S/D 97-63 -- One-Step Final Plat of CELLULARONE ADDITION
September 4, 1997 - Page 3

**UTILITY PLAN
CELLULARONE
WICHITA, SEDGWICK COUNTY, KANSAS**

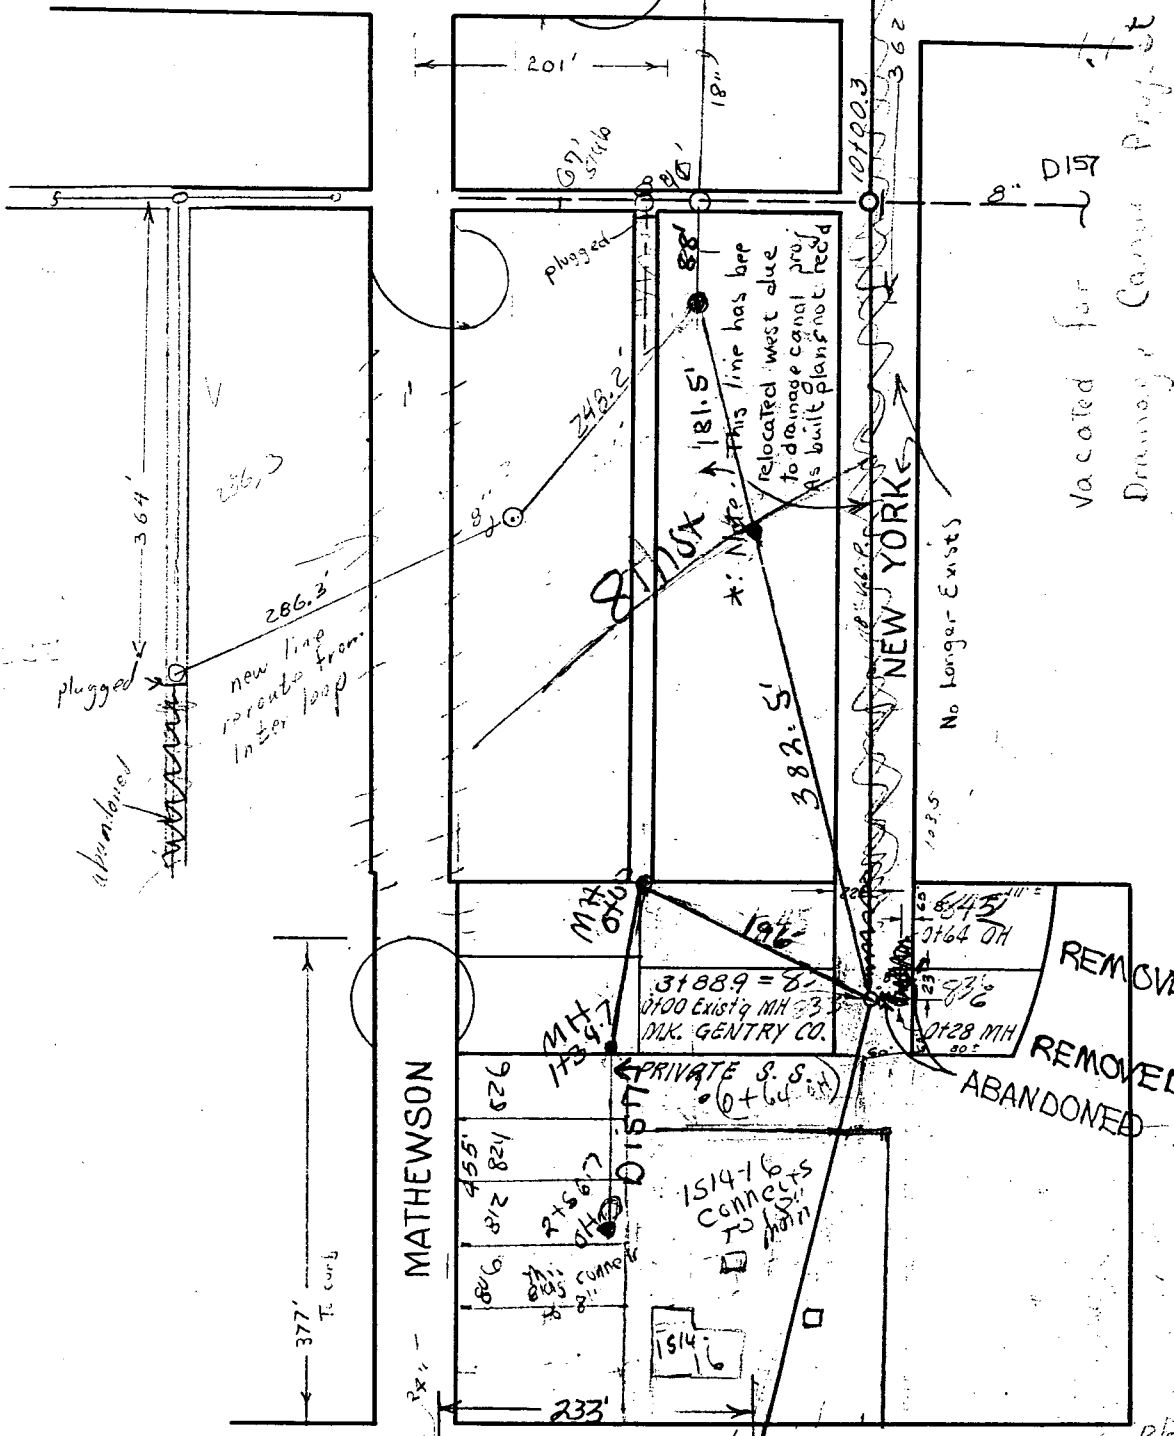
- A. Municipal services appear to be available to the site. **City Engineering** needs to comment if any additional guarantees are required and/or the need for any additional easements.
- B. The applicant shall guarantee any drainage improvements required by the platting of this property.

City Engineering should be ready to comment on the applicant's drainage plan.
- C. **Traffic Engineering** should comment on the need for any improvements to Murdock, as well as if the number of access points shown are appropriate.
